Objections to Planning Application 16/0669/MOUT

Land at Two Bridges Road, Sidford

Cllr Marianne Rixson & Cllr Dawn Manley

5th June 2016

APPENDIX D – Map of narrow roads, Sidford & Sidbury

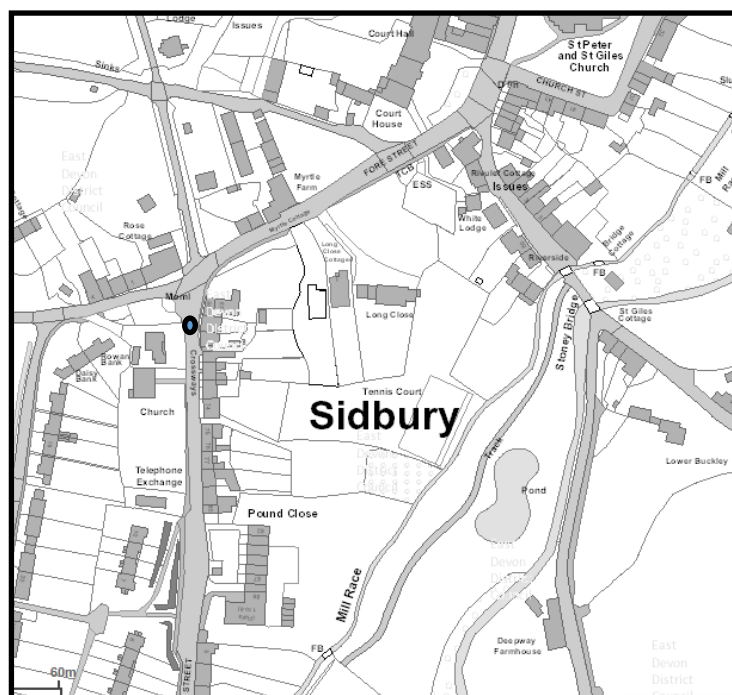
School Street Sidmouth: circle marks point where roadway is 4.77 metres wide

Crossways, Chapel Street Sidbury: circle marks point where roadway is 5.3 metres wide

Bat Survey Transect and Static Detector Locations

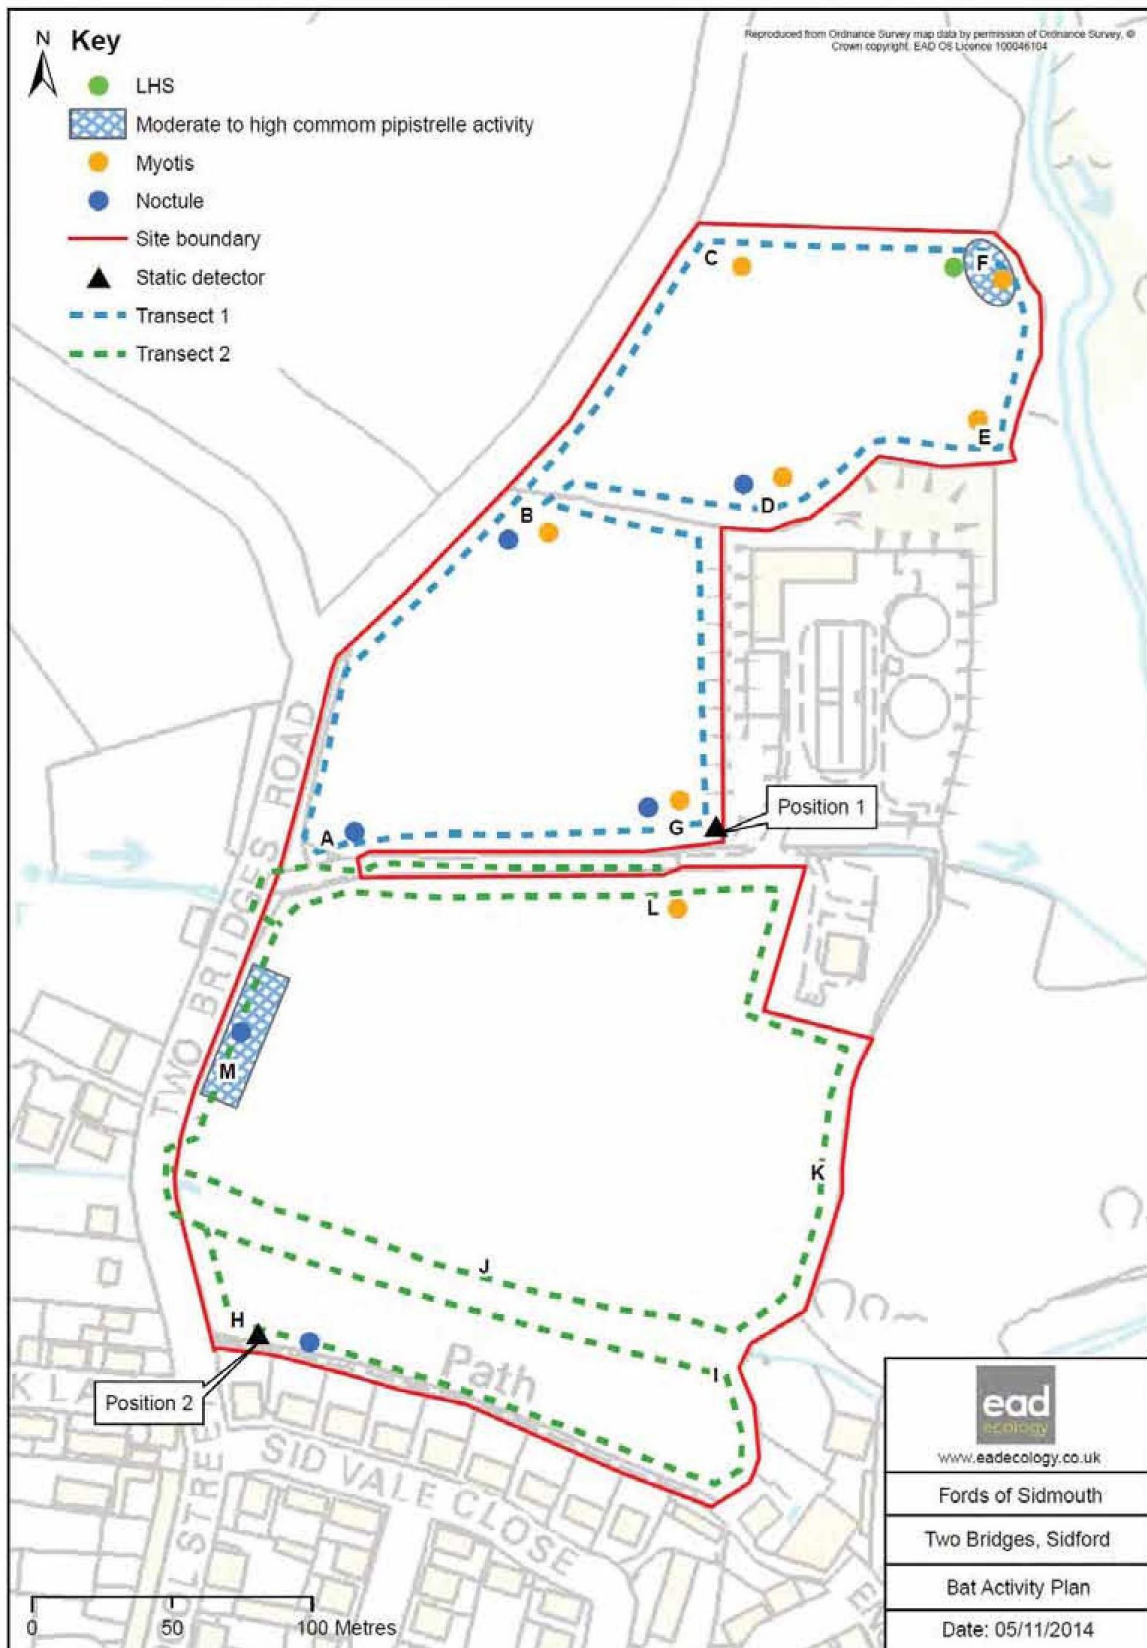
The area around static detector position 1 (see map below) is key and should be brought to attention with reference to the final lighting design. Greater Horseshoe *Rhinolophus ferrumequinum* were recorded at this position and although only a small number of passes were recorded it is highly likely that the actual activity for these and the Lesser Horseshoe *Rhinolophus hipposideros* species, (both Annex II species of the European Habitats Directive) will be much higher. This is due to the horseshoe bats having very directional calls which only travel a short distance and are picked up by a detector often less than 25% of the time. The Long Eared bats may also have been under recorded due to their calls being very quiet and therefore not easily picked up by a detector, meaning there may be higher bat activity in the area than recorded.

At stopping points A, F, L, and M the highest activity was recorded. Stopping point F had the highest activity, where the habitat is going to be enhanced through tree planting and provides adequate compensation for the bats in this area.

Areas surrounding stopping points A, L and M to the southwest of the site are going to undergo significant habitat loss which will be highly detrimental to bat species. The surrounding stopping points A and M will both be directly affected by the removal of hedgerows as these provide commuting routes. The Annex II Lesser horseshoe and Greater Horseshoe are dependent on hedgerows as they regularly fly only 1 metre or lower above the ground. They not only use the hedgerows as commuting guides but also use mature hedgerows as shelter from any prevailing winds whilst using the flyway.

Any removal of large sections or complete hedgerows especially H3, H5 and H7 (as named in the Arb Report) will have a detrimental effect on foraging and commuting routes for bats. Flyways through valleys provide connectivity, often from roosts present within buildings, and the wider environment. Any impacts on these vital flyways should be evaluated closely.

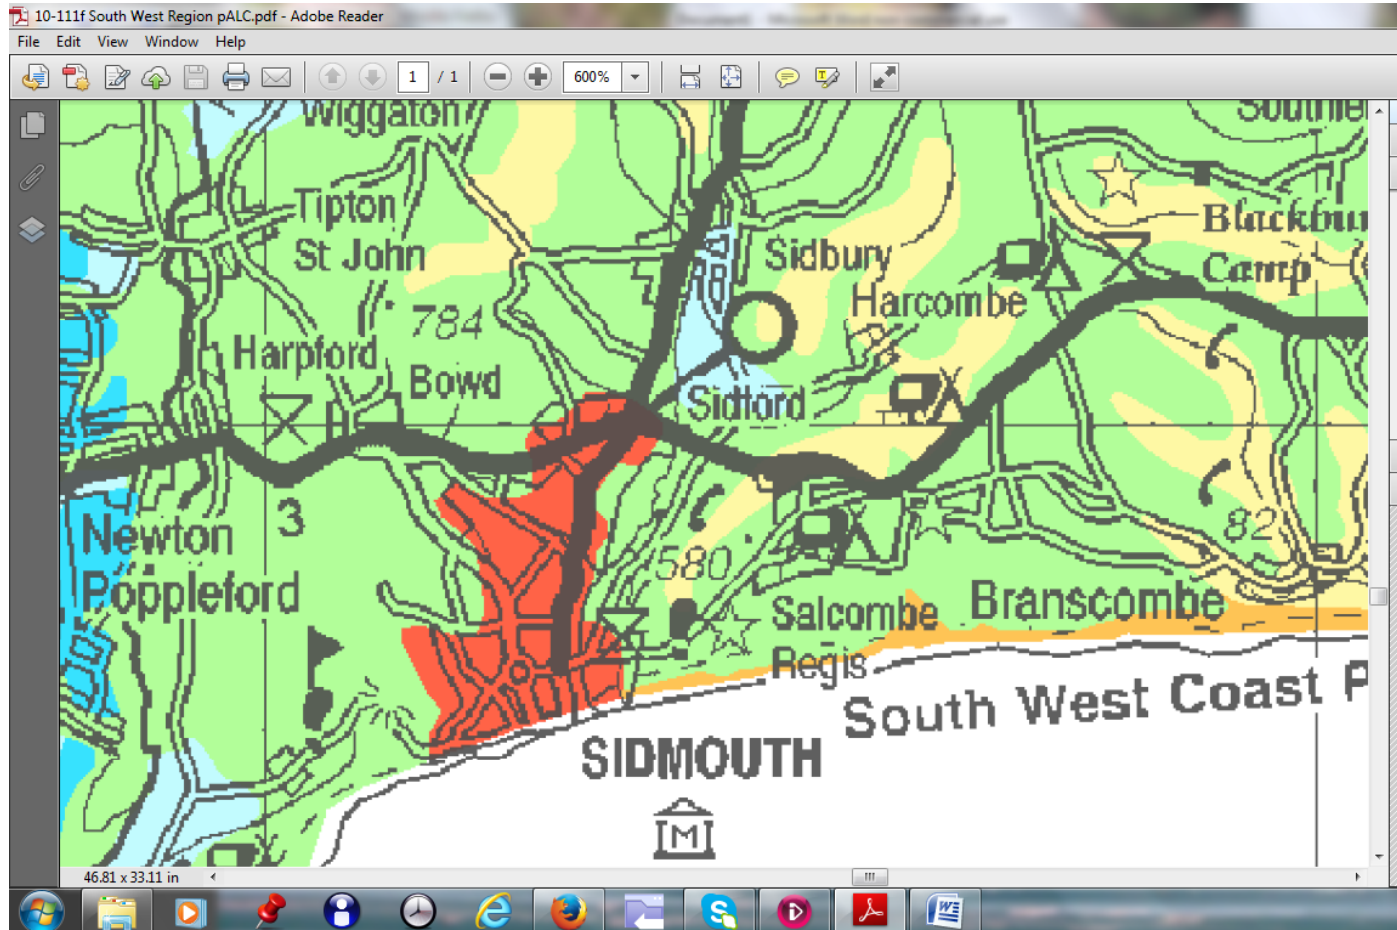
A slow worm *Anguis fragilis* was observed on 1st June 2016 by Louise Woolley on Laundry Lane. As works are going to cause disturbance to this lane it is therefore essential that this area is also included within the reptile translocation site to reduce the risk of death to reptile species. This should be put in place before any works affecting this lane commence.

Previously this area was not surveyed as it was outside of the site boundary, therefore it was not included in any mitigation strategy (see map).
